Ameristar Air Cargo, Inc. dba Ameristar Charters Ypsilanti, Michigan March 8, 2017 DCA17FA076

ATTACHMENT 3

Zodiac Aerospace CMM 3 - Pages

COMPONENT MAINTENANCE MANUAL D37013

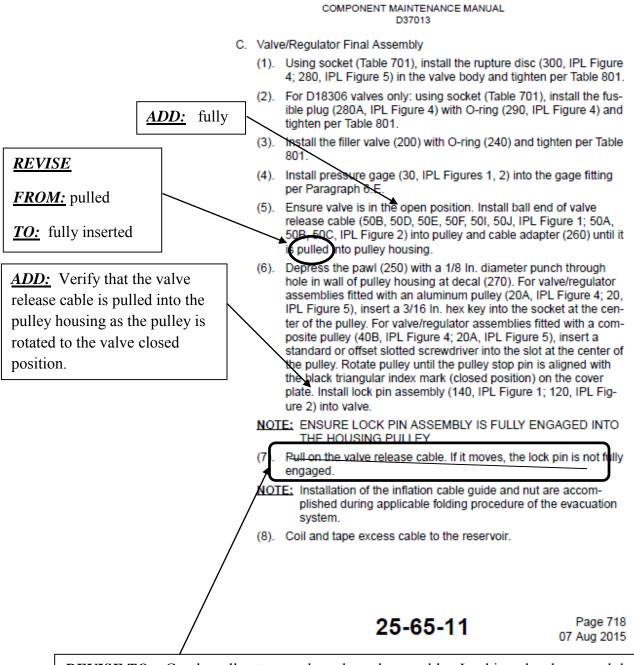
3. Add the following revisions to CMM Assembly section 7 paragraph B:

- B. Arm valve/regulator (Figure 709)
 - (1). Rotate reservoir in chain vise until pulley housing is facing up.
 - (2). For valve/regulator assemblies fitted with an aluminum pulley (20, 25, IPL Figure 3; 20A, IPL Figure 4; 20, IPL Figure 5), insert a 3/16 In. hex key into the socket at the center of the pulley. For valve/regulator assemblies fitted with a composite pulley (40B, IPL Figure 4; 20A, IPL Figure 5), insert a standard or offset slot-ted screwdriver into the slot at the center of the pulley. Slowly rotate pulley until stop pin is a opposite end of its arc of motion

(6) Gently pull on valve release cable. If it moves the stop pin is not fully engaged.

<u>REVISE TO</u>:

....opposite end of its arc of motion, farthest away from the black triangular index mark on the cover plate.

<u>ADD</u>: Verify that the valve release cable is pulled into the pulley housing as the pulley is rotated to the valve closed position.

<u>REVISE TO:</u> Gently pull or tug on the valve release cable. Looking closely around the gaps in the valve cover assembly on the inflation valve, verify that there is slight movement of the pulley and the lock pin due to the movement of the valve release cable. The valve release cable should not pull free of the inflation valve assembly. If the valve release cable can withdraw from the valve assembly, either the lock pin is not fully engaged or the inflation cable was not fully inserted into the pulley during the arming procedure. Repeat steps (3) thru (5) to resolve unacceptable cable movement.
